# Application for Variance

Property Address: 16308 Jackson Street  
 Legal Description: LOT 16 BLK A VILLAGE AT VOLENTE PHG 2  
 Acreage: 1.2900 Is property within floodplain? NO

Project for Which Variance Is Sought: New Overhead Power Pole for Power to Property + Primary Pole to bring power to property  
 Applicable Section/Subsection of Ordinance: Sec. 9.05.124

**Re: Variance Review**

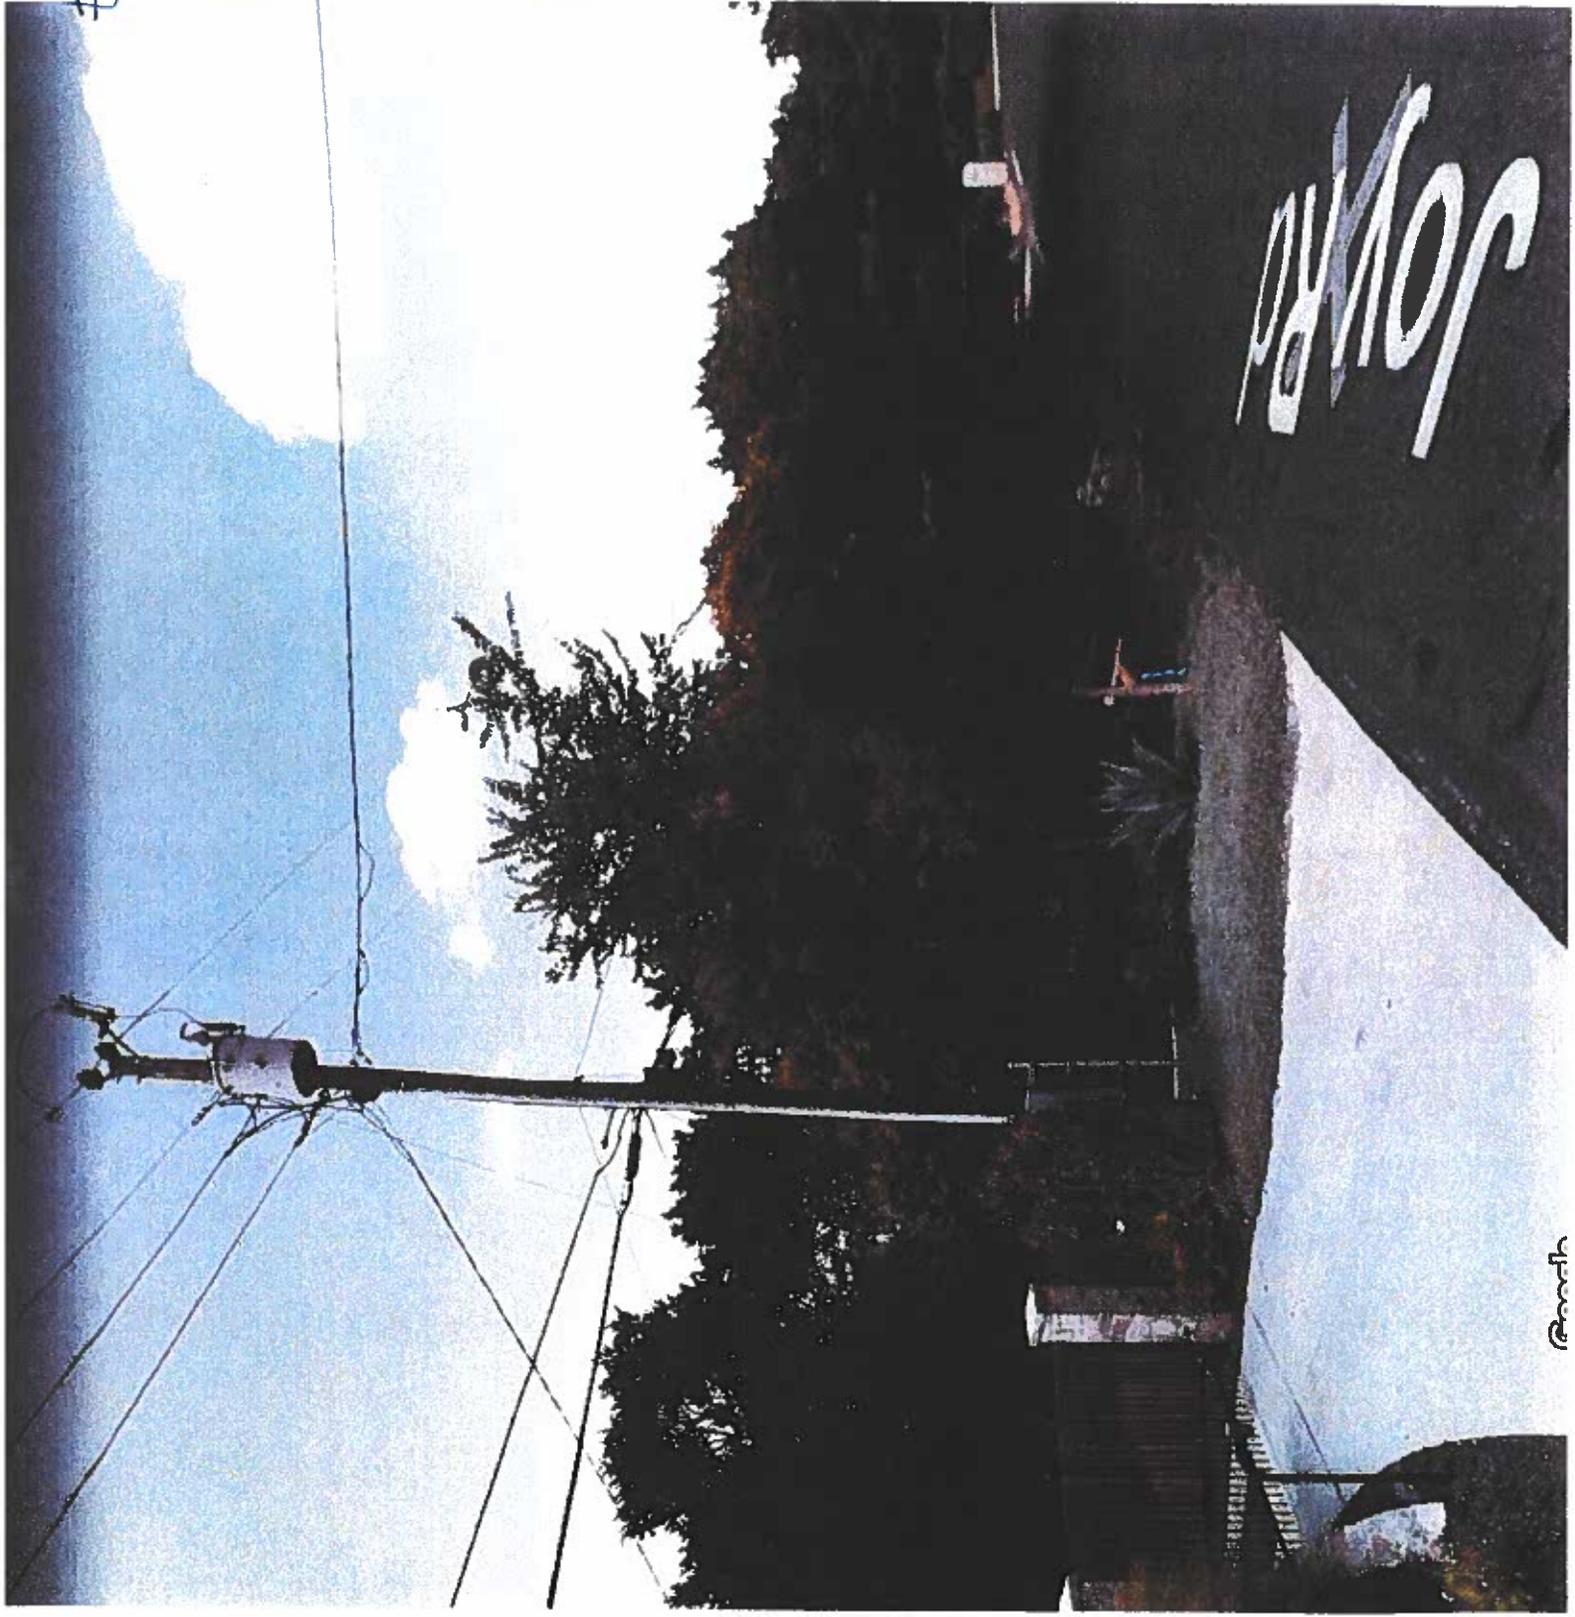
16308 Jackson: The existing overhead powerlines are on the same side of the property however PEC is requiring two poles, a pole in the PEC easement and another pole on site. This type of variance in the past was handled by one new pole and a weather head drop in the easement along the main pole which would reduce the number of poles in the Village. See the attached image.

My opinion is that the Village needs to work closely with PEC to come up with power supply alternatives for overhead power and crossing the street or we are going to have more and more overhead in the community. If you have any questions or need any additional information please feel free to call or email me at 512.297.8651 or [marc.dickey@gmail.com](mailto:marc.dickey@gmail.com).
